Havelock Village Ltd amendments to Chapter 16 Residential Zone, Chapter 23 Rural Lifestyle Zone and Consequential Amendments

30 June 2021

Figure 16.4.18A

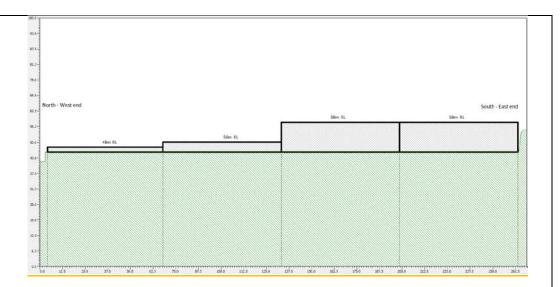
- (iv) Either prior to or concurrent with subdivision in Lot 2 DP199997, an acoustic barrier (being a bund, building (including its roof) or structure, or any combination thereof) must be constructed within the Havelock Precinct Plan's General Industry Zone to mitigate potential noise from the adjoining Light Industry Zone (Lots 3 and 4 DP 492007) to achieve noise levels no greater than 45 dB L_{Aeq} between 10pm and 7am in the Havelock Precinct Residential Zone. The specification of the acoustic barrier must be at a height of no less than that illustrated on figure 16.4.18A below and a length along the entire common boundary between Lot 2 DP199997 and Lots 3 and 4 DP 492007 (excluding the Collector Road on the Precinct Plan and 5m front yard setback – Rule 20.3.4.1). The application shall be accompanied by an acoustic design report to ensure that the acoustic barrier will meet the requirements listed in this rule and that it will perform as an effective acoustic barrier. The design and effectiveness of the acoustic barrier shall be based on the requirement to reduce the extent of the unmitigated 45 dB L_{Aeq} noise contour illustrated on figure 16.4.18B below. The Pokeno Industry Buffer illustrated on Lot 2 DP199997 is based on compliance with and implementation of this rule.

Figure 16.4.18B

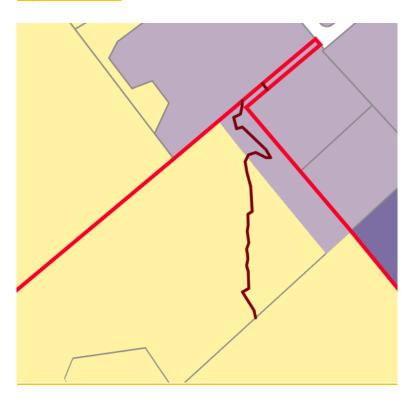
- ii. Until the acoustic barrier has been constructed and made acoustically effective in accordance with Rule 16.4.18 RD1 (a)(iv), the noise rating level from activities on Lots 3 and 4 DP 492007 must not exceed 55dB L_{Aeq} from 7am to 10pm every day, 45 dB L_{Aeq} from 10pm to 7am the following day and 75 dB L_{Aeq} from 10pm to 7am the following day measured from the unmitigated 45 dB L_{Aeq} noise contour illustrated on figure 16.4.18B. When Rule 16.4.18 RD1 (a)(iv) has been satisfied, clause (b)(i) above applies.
